Official Transcript of Proceedings
NUCLEAR REGULATORY COMMISSION

Title: Advisory Committee on Reactor Safeguards
 Plant License Renewal Subcommittee

Date: Wednesday, December 1, 2010

**Advisory Committee on Reactor Safeguards (ACRS)
License Renewal Subcommittee
Salem Nuclear Generating Station, Units 1 and 2 (Salem)
Safety Evaluation Report (SER)
with Open Items
December 1, 2010**

Salem Unit 1 Spent Fuel Pool Leakage Path

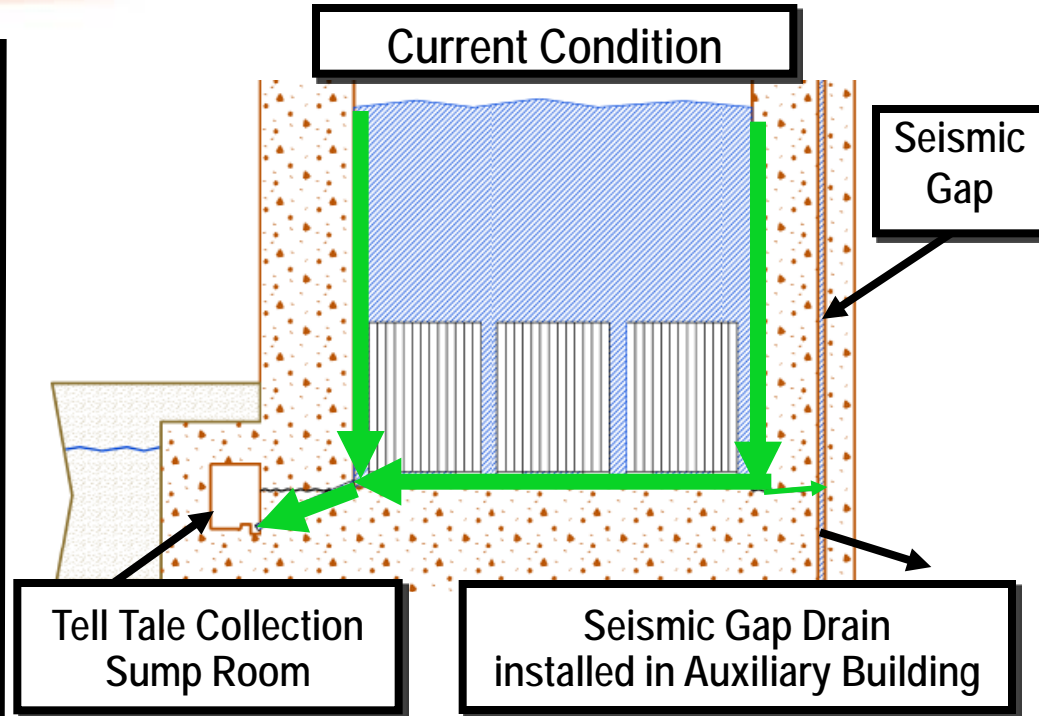
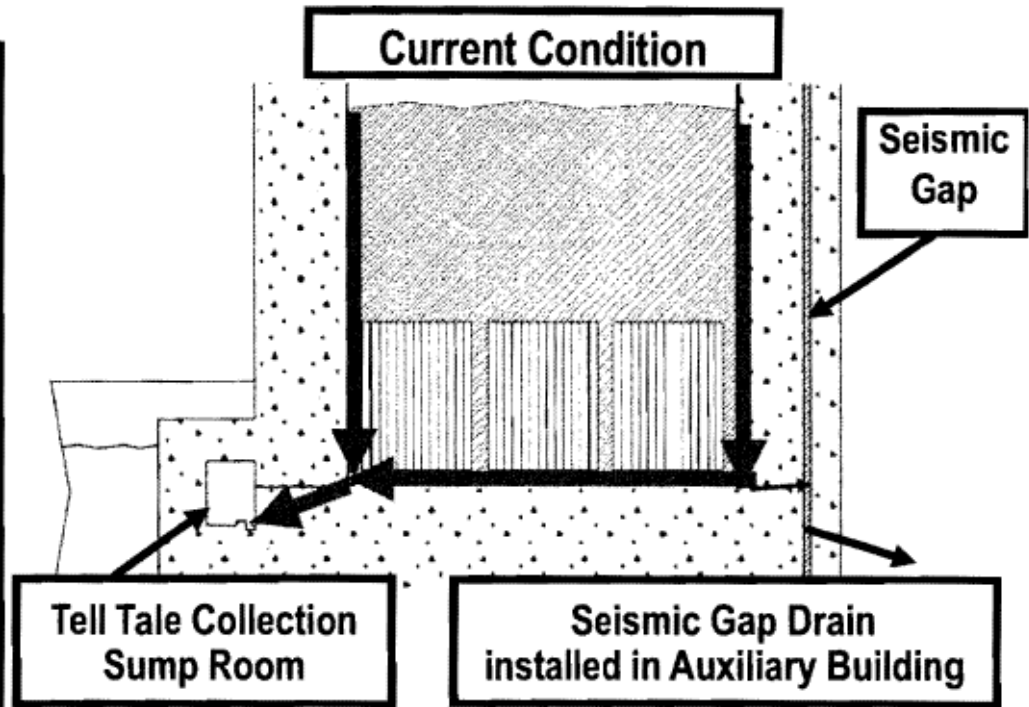
2 CHAIRMAN STETKAR: So the seismic gap
3 that you are talking about on this drawing, which
4 is pretty difficult to see with my old eyes. The
5 seismic gap is that vertical gap right there
6 where the cursor is.

17 MEMBER SIEBER: So putting a drain
18 in, the remainder, and seven years, that's 2-1/2
19 million gallons of water. That's a fair amount
20 of water. It would seem to me and correct me if
21 I'm wrong, but it would seem to me that
22 installing drains will not prevent the leakage.

23 MEMBER SIEBER: 34, yes, but the leak
24 continues. And under your plan it will always
25 continue.

6 MR. KEATING: Sure. Good afternoon.
7 My name is Ed Keating. I am with the license
8 renewal project. This map you are looking at is
9 the plume map, which I believe we are going to
10 get to questions later. The seismic gap drains
11 are intended to keep the seismic gap below the
12 level of grade that would overflow into the
13 environment. We've installed a ground water
14 recovery system of 36 wells, six wells of which
15 are pumping wells. And those wells are removing
16 the shallow ground water at a rate 15 times that
17 at the recharge rate of the area. So you can see
18 in the drawing up here, the large circle in the
19 center of the drawing is the containment. The box
20 to the left of it is the fuel handling building
21 and the seismic gap is that darkened area in
22 between the two. The map on the left shows the
23 concentrations of tritium, relative
24 concentrations of tritium in a plume. The dark

- Tell Tale Drains are maintained open to ensure leakage is captured
- Seismic Gap Drain installed in the Auxiliary Building to ensure any leakage is captured
- No additional contamination is exiting the structures

Buried Pipe Program – Unit 1 AF Piping

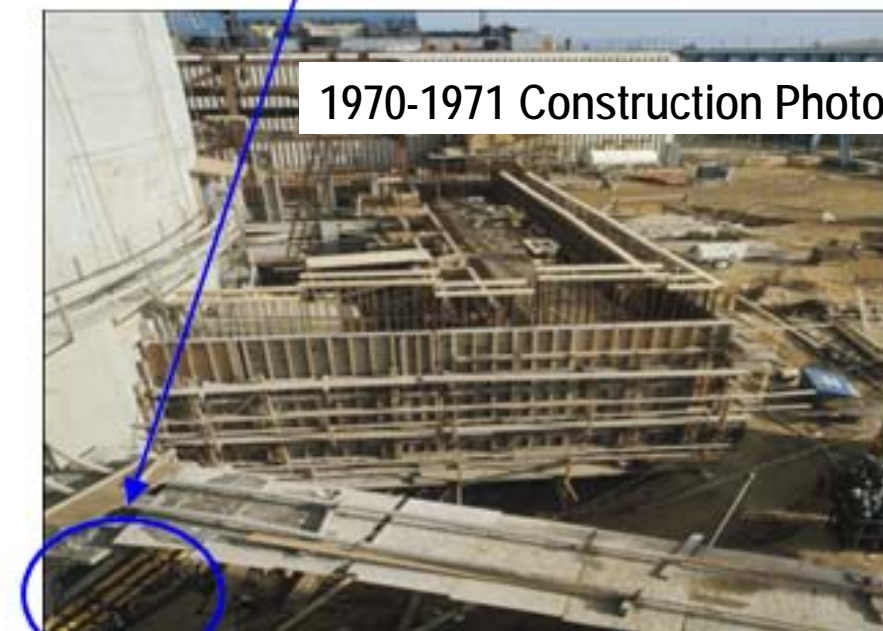
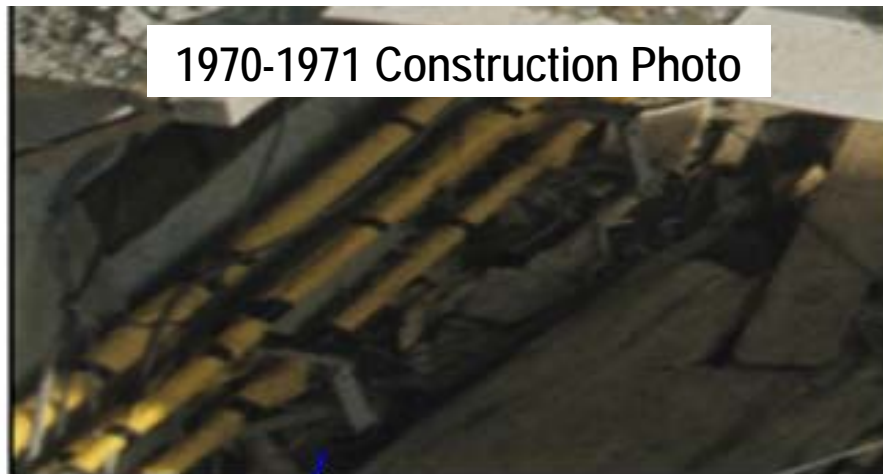
2 MR. BARTON: The implication of this is
3 none of the pipe was coated. Is that correct?

5 MR. BARTON: Okay. Did you replace
6 it with the same material or different material?

1 However, because the pipe coating and the
2 protective yellow, protective wrap are yellow,
3 direction was given to remove the protective
4 wrap. They took the coating off as well. And
5 you can see that in the picture. It looks like,
6 right at the wall, it looks like a yellow plastic
7 wrap was torn off the pipe. Based on the fact
8 that the Unit 2 auxiliary feed water piping and
9 the fuel transfer tube area on the Unit 2 once
10 again, had its yellow coating intact as well as
11 properly installed coating in other excavations
12 on site at Salem, which included this was a one
13 time isolated incident where the coating was
14 inadvertently removed during original
15 construction.

Salem Unit 2 Liner Knuckle Plate Thickness – October 2009

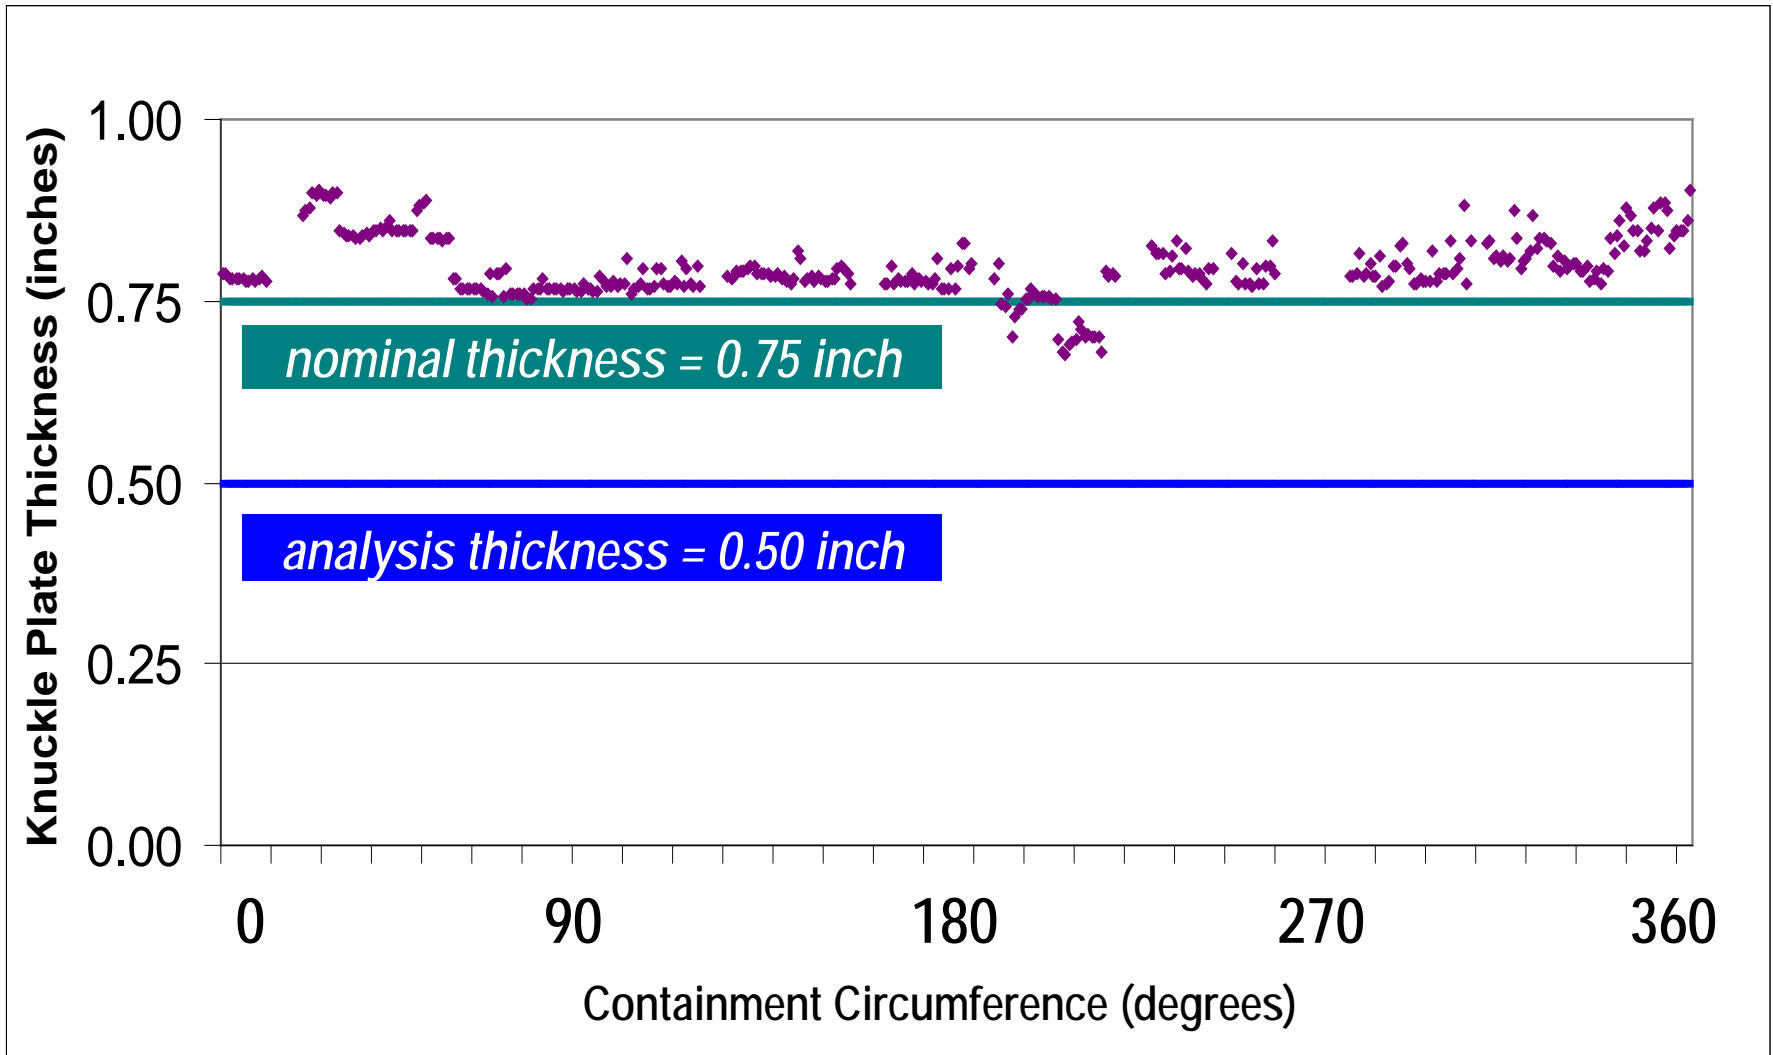
23 CHAIRMAN STETKAR: Alan, if you go to
24 the Unit 2 slide that showed the, number 33.
25 That area where you did show the increased,
